North Harbour 2 Watermain and
Northern Interceptor in Shared Corridor

**AMENDMENTS TO VOLUME 2 TECHNICAL REPORTS -
LETTERS FROM TECHNICAL SPECIALISTS FOR
OPTION 2 AT ALBANY RESERVOIR**

North Harbour 2 Watermain - Earthworks, Erosion and Sediment Generation for Albany Reservoir Option 2

Attachment to the Traffic Assessment Letter dated 24 May 2016 - NOR2 Option 2 at Albany Reservoir: Marked up Drawing

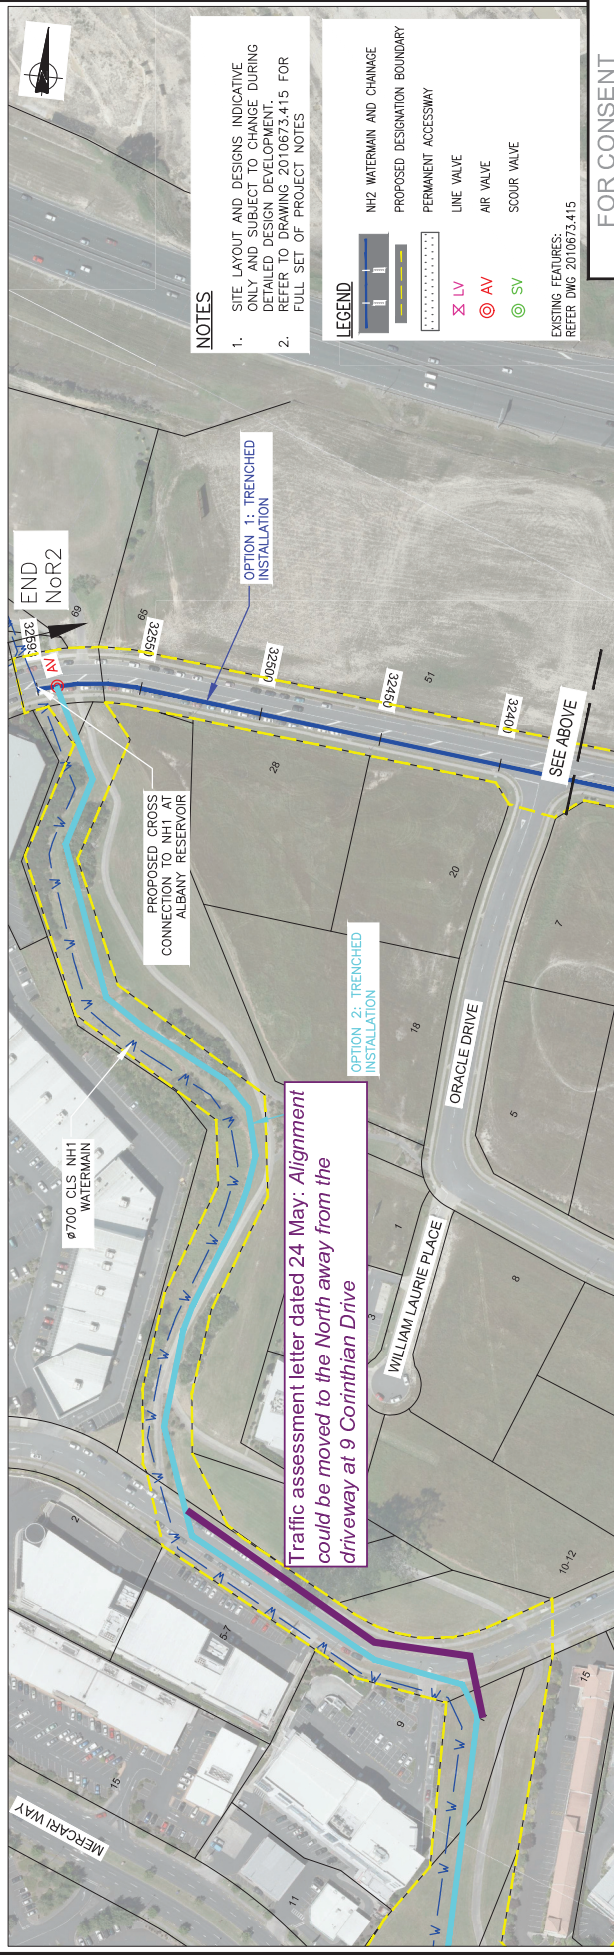
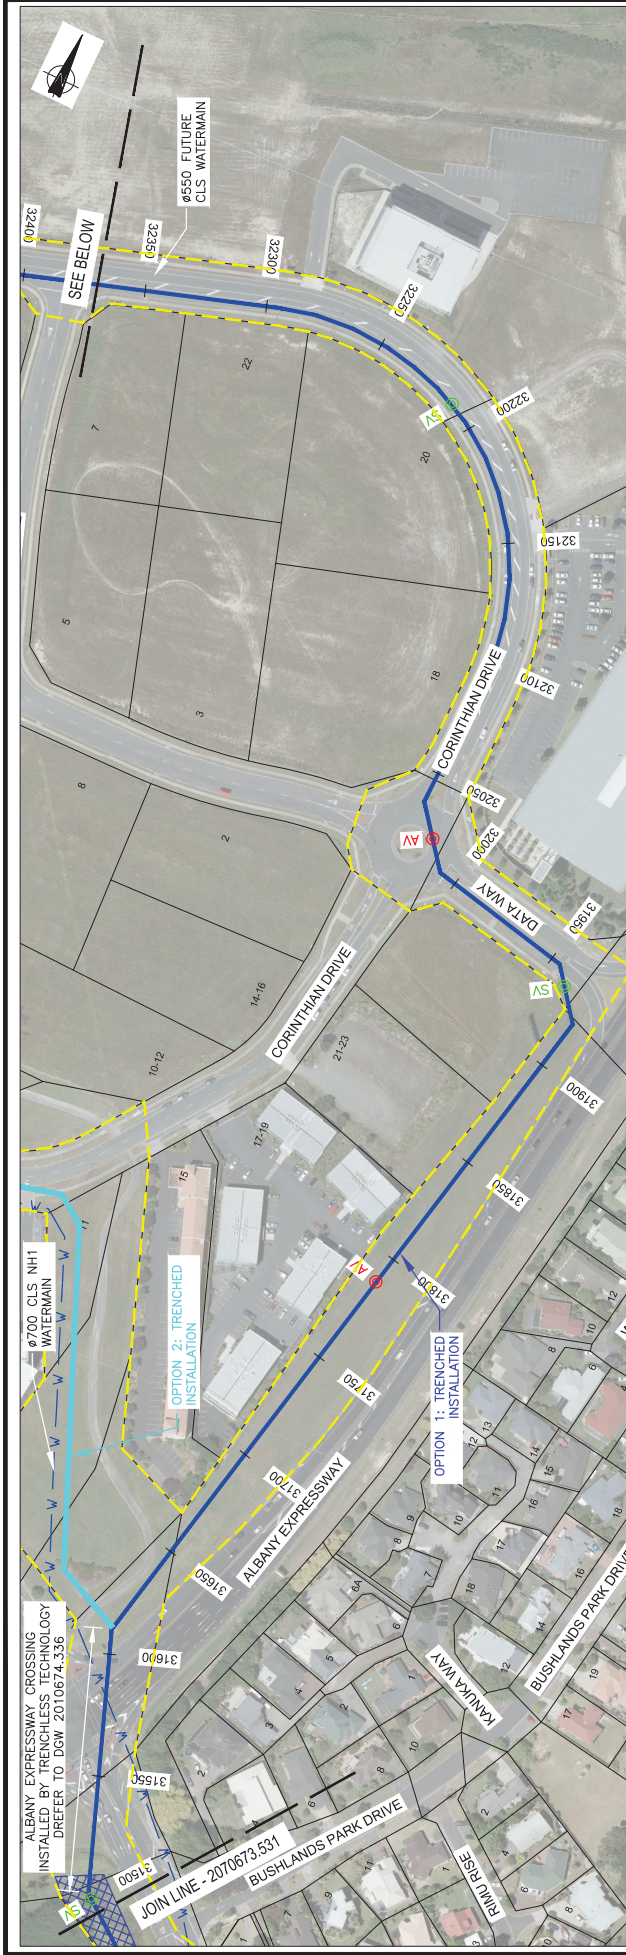
It should be noted that the section of road near 9 Corinthian Drive would likely be restricted to only 1 lane of traffic during construction. The current alignment of Option 2 would block the driveway to 9 Corinthian Drive during construction. To mitigate this effect, one of the following measures is recommended:

1. Option 2 alignment could be moved to the north side of the road as the current alignment would block the driveway during construction (see attached sketch).
2. Complete the construction work in the vicinity of 9 Corinthian Drive during off peak periods (i.e., nights, weekends or holidays) to minimise the impact
